ADMINISTRATIVE AMENDMENT

**Project 528
Shops Facade**
3400 NM 528
Albuquerque NM

Site Plan for
Administrative Amendment
Building Permit
AS101

EXISTING AND PROPOSED
 FACADE FLOOR PLAN
 AND EXTERIOR ELEVATIONS

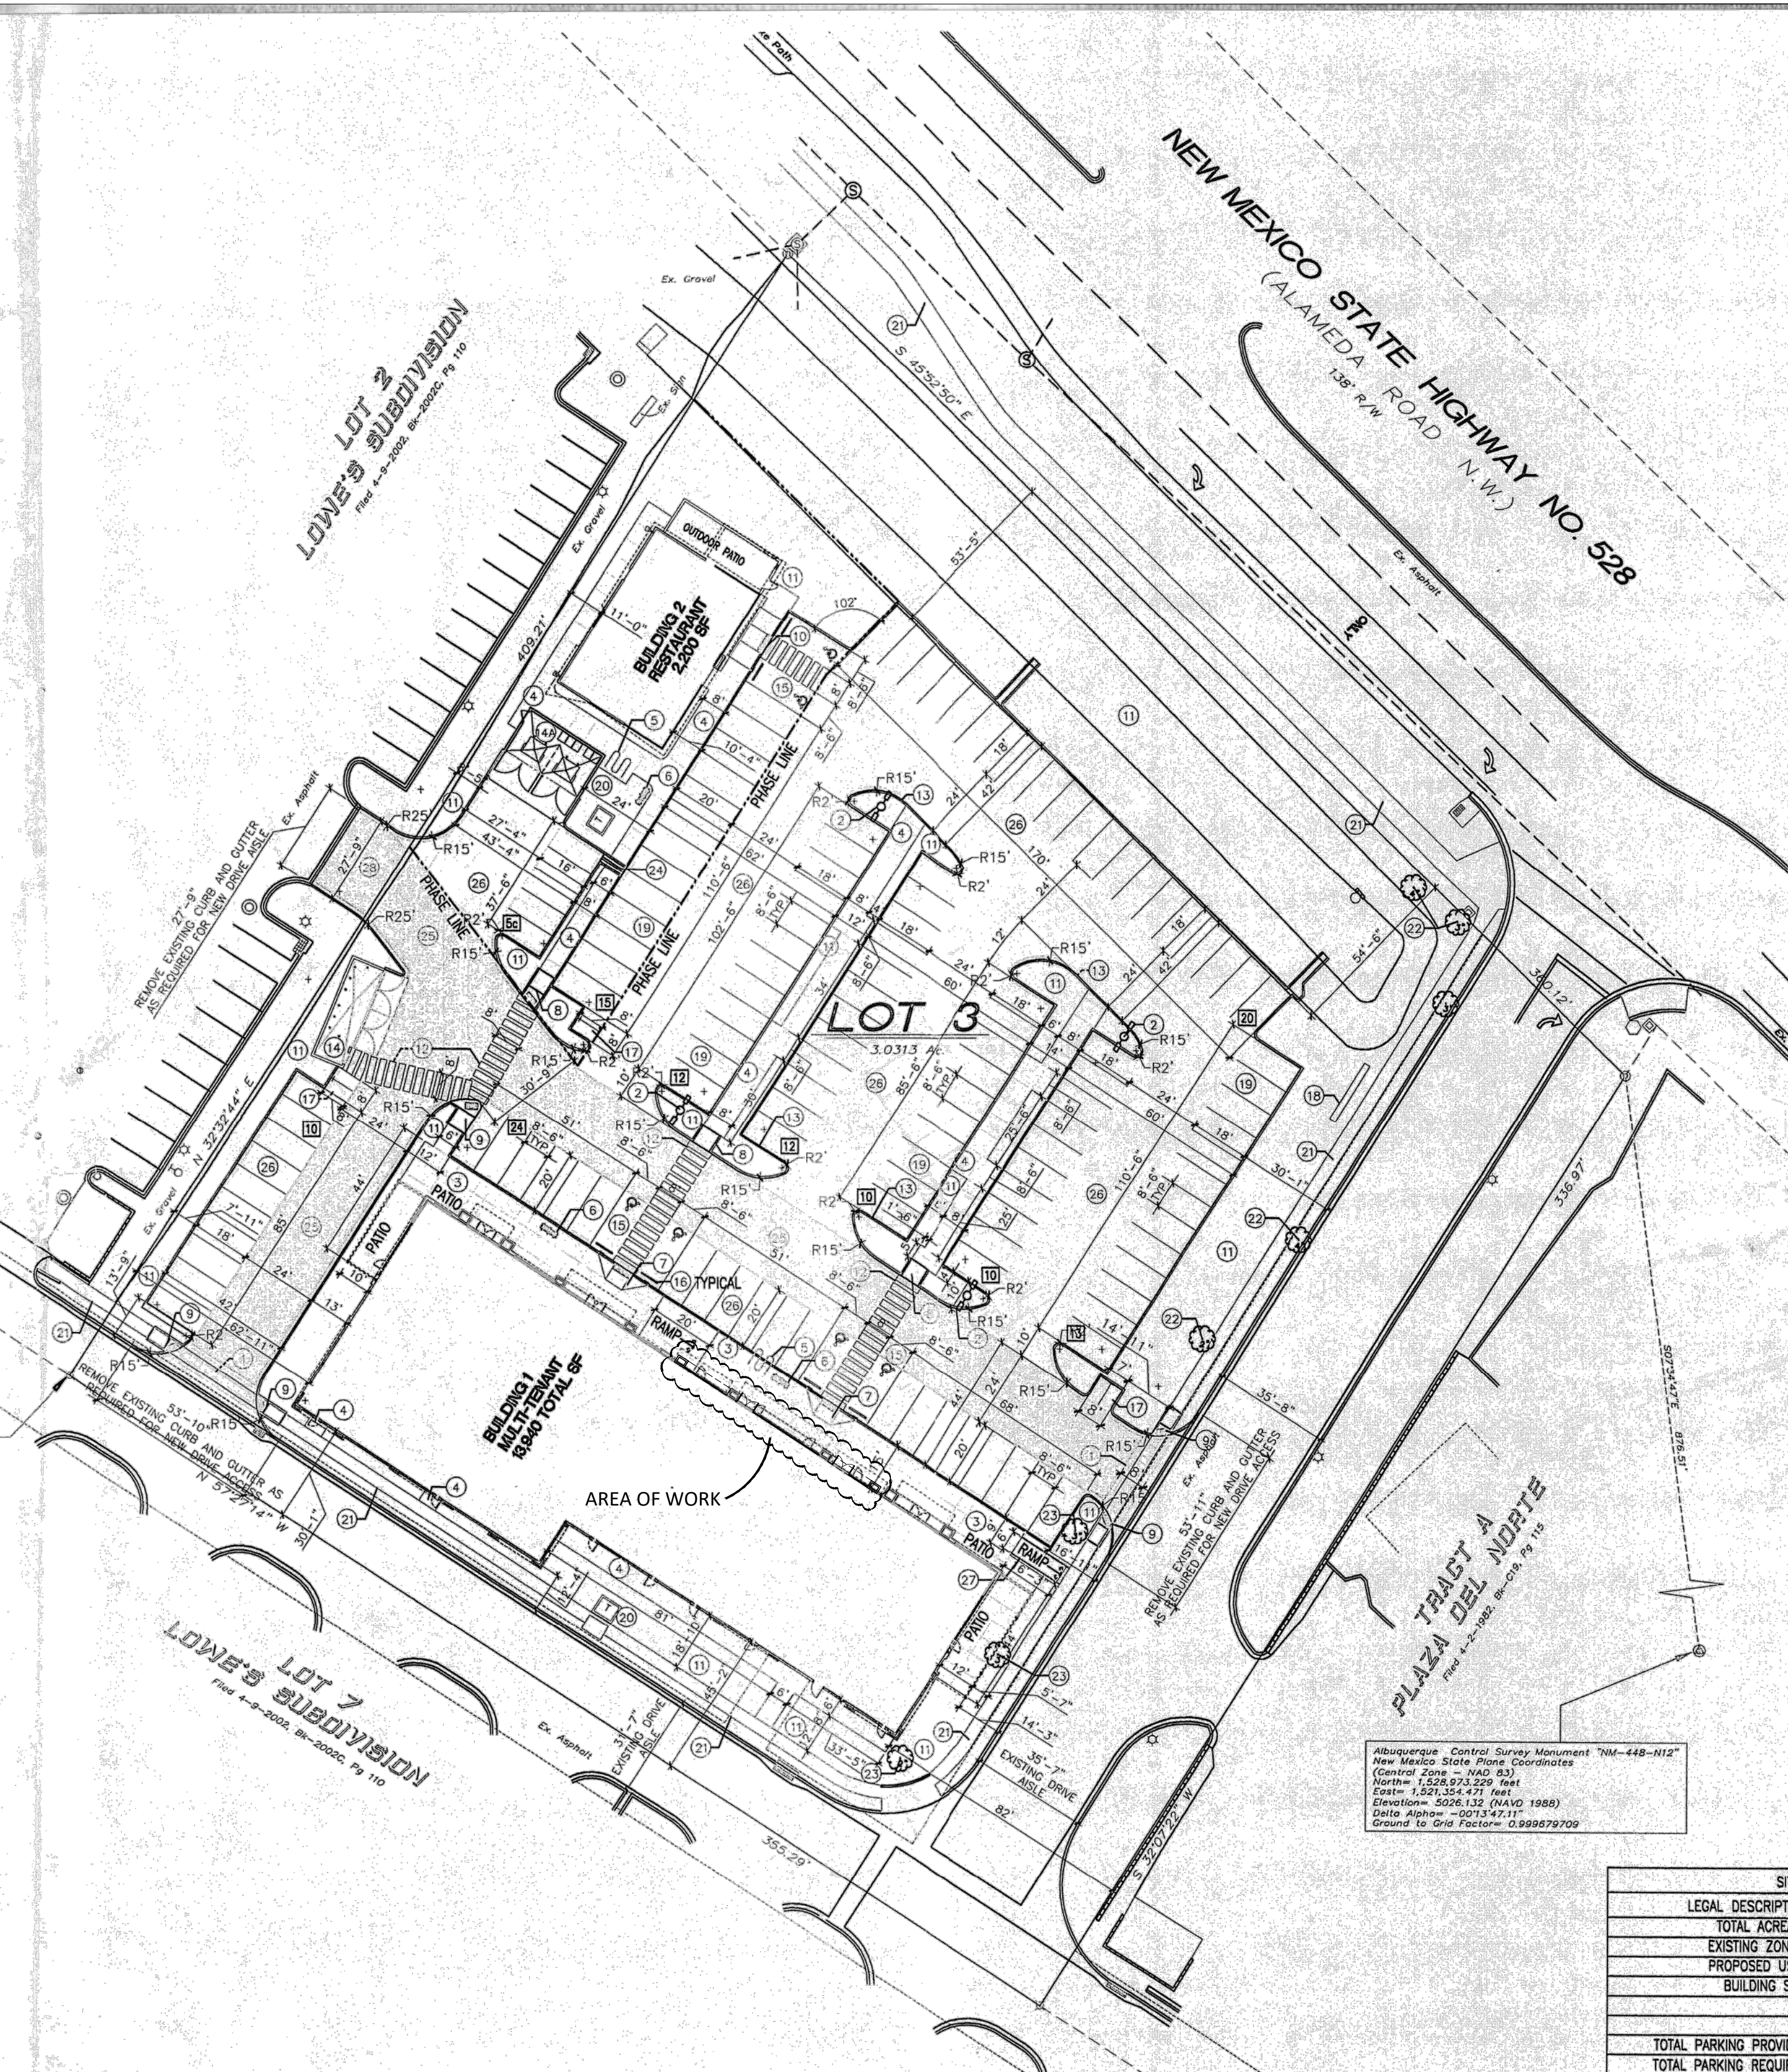
IDO Protection Zone Coors Boulevard CPO-2
Project includes Facade addition (footings, framing, finishes) to match existing and falls within requirements for Minor Administrative Amendment shown in IDO Table 6-4-4. Addition of 18 sf of gross square footage. Setbacks, height and parking to remain unchanged. No sitework. Signage to be under separate permit.
